Development Review Board

Tuesday, August 6, 2024, 5:00 PM

ZAP-24-5; 151 Ledge Road (RL, Ward 6) J. Kathleen Tracy

To: Development Review Board
From: Mary O'Neil, AICP, Principal Planner
Date: August 6, 2024
RE: ZAP-24-5; 151 Ledge Road

New Duplex Build
at
206-208 Dale Rd.
Burlington, Vermont

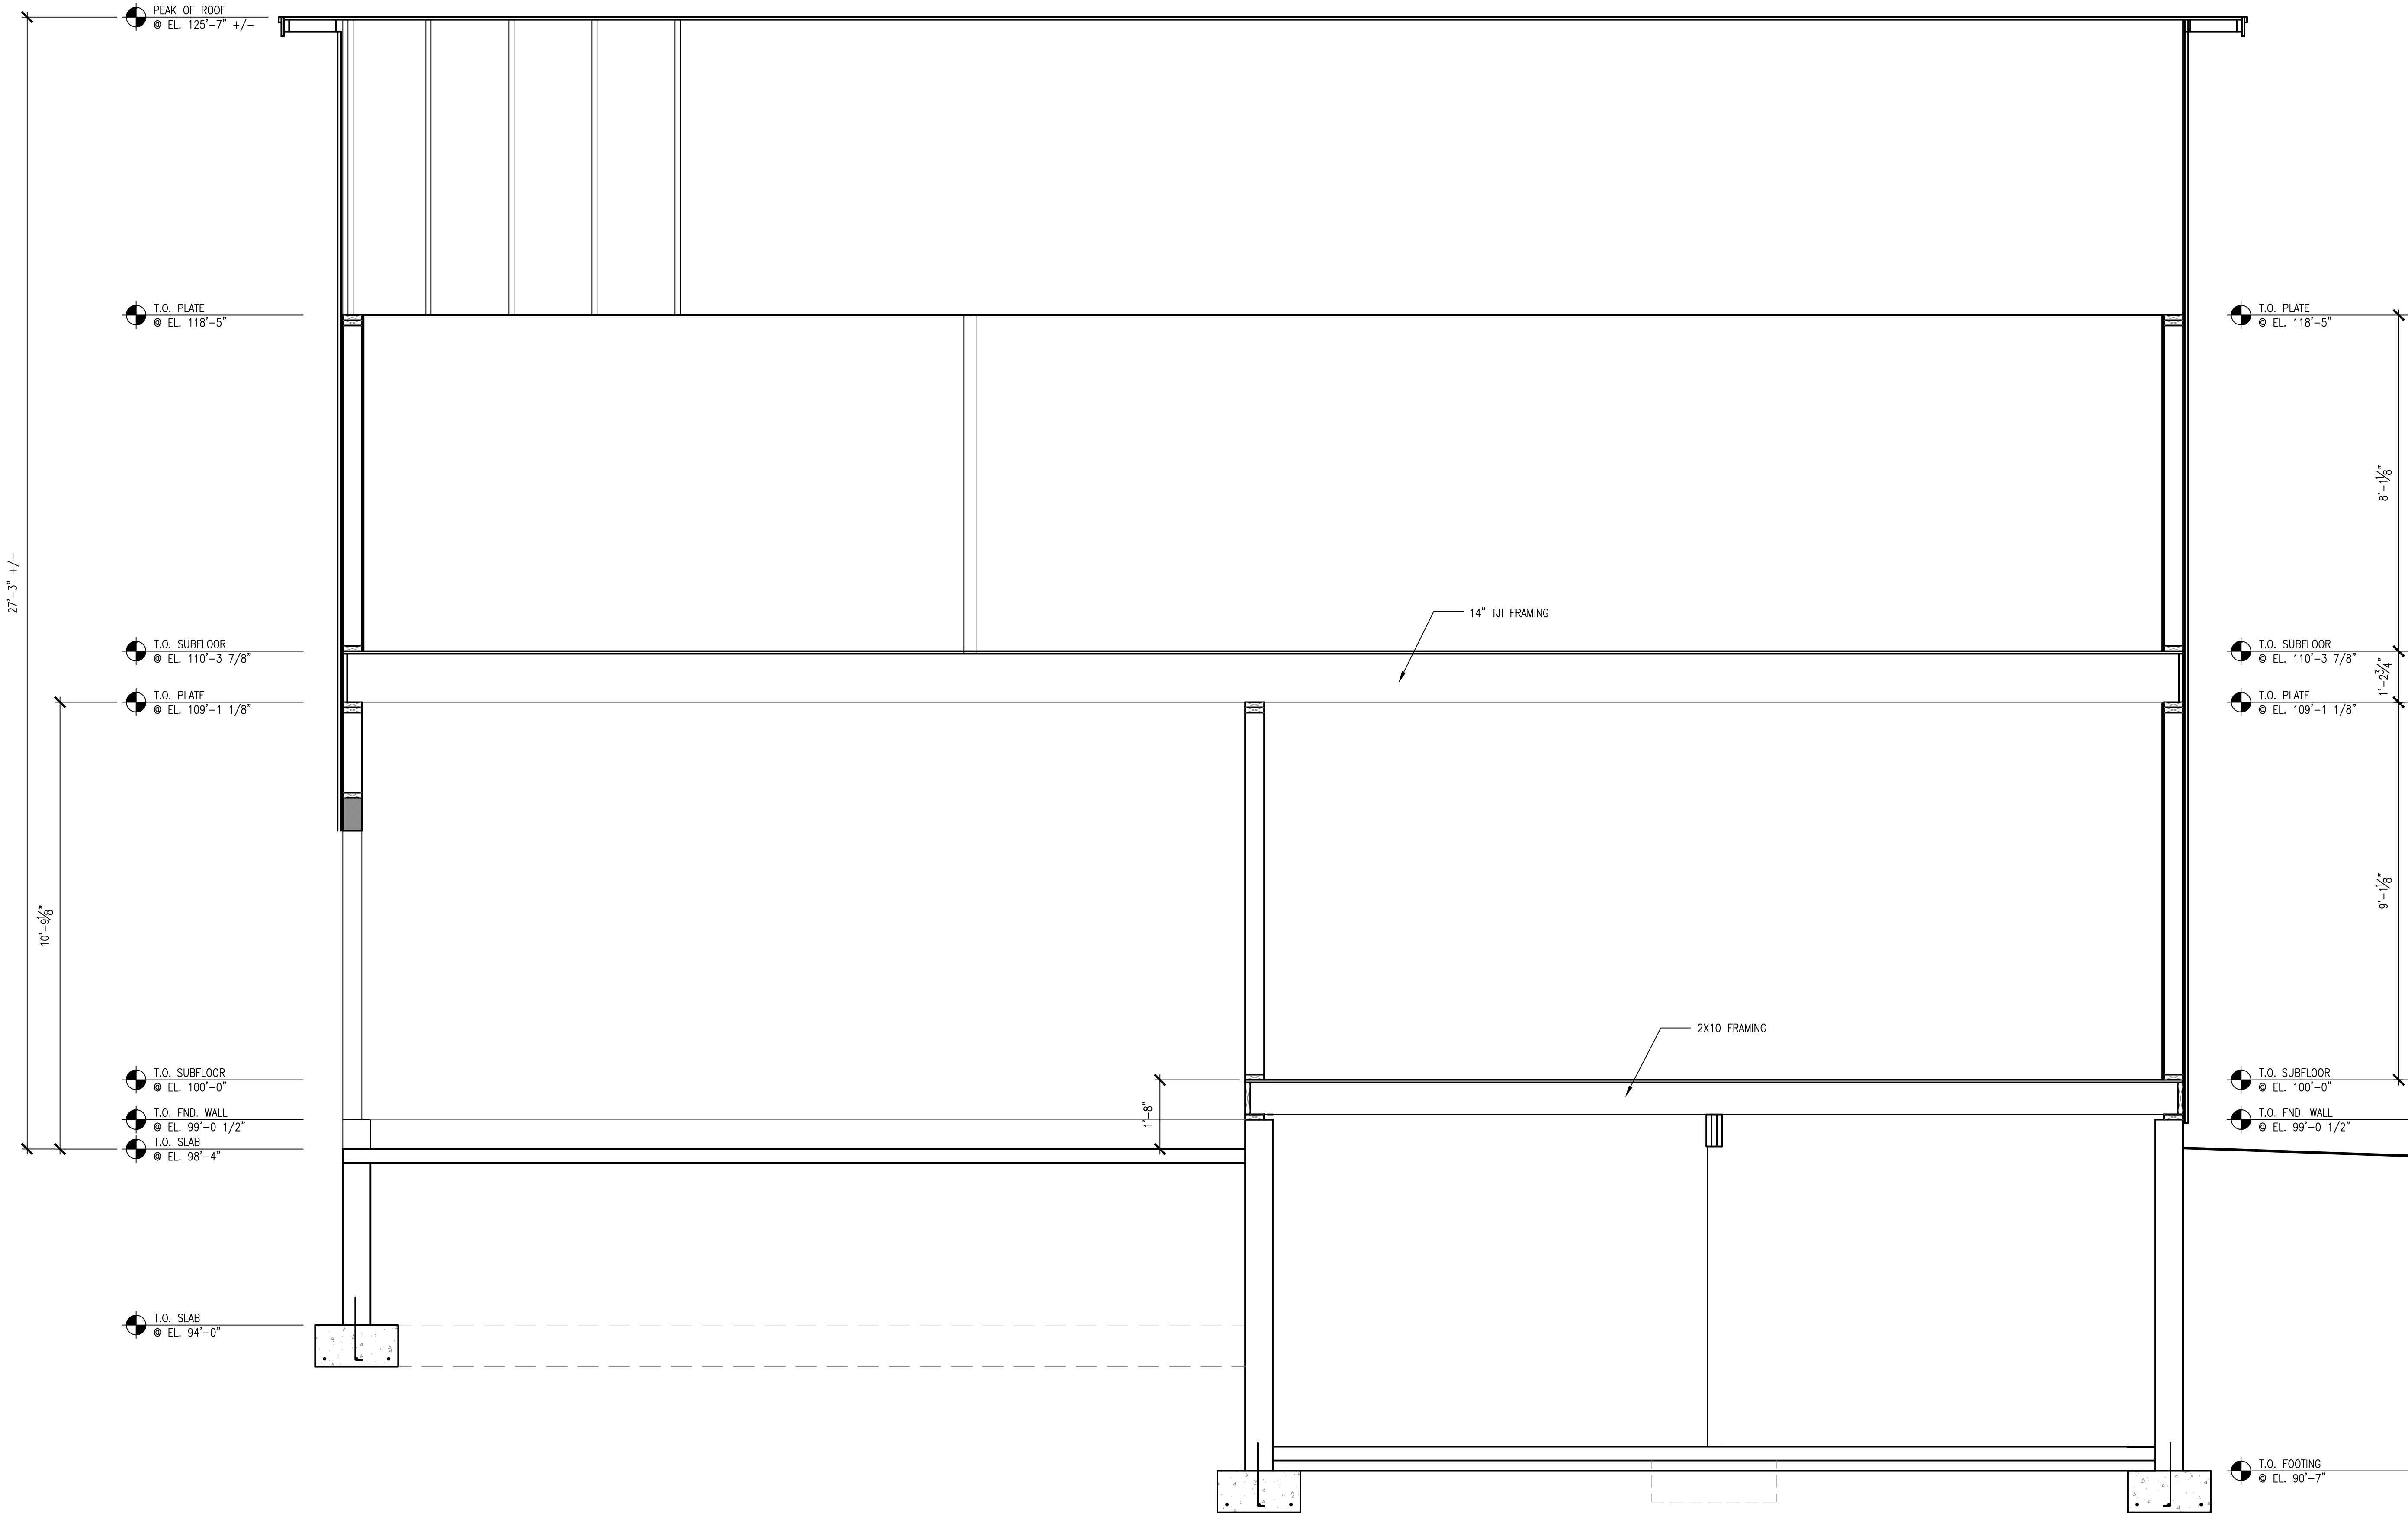
Condensing units are illustrated at the northwest (side) elevation. Mailboxes are adjacent to front entrances. Trash and recycling will be located within the garages. Utility meters are located on a side (northwest) elevation. Reference is made to Plan A2.1. **Affirmative finding.**

Plan A2.1 defines the intention of asphalt shingle roofing, composite board and batten in the gable ends and vinyl siding for the bulk of the structure. All are considered acceptable for new construction.
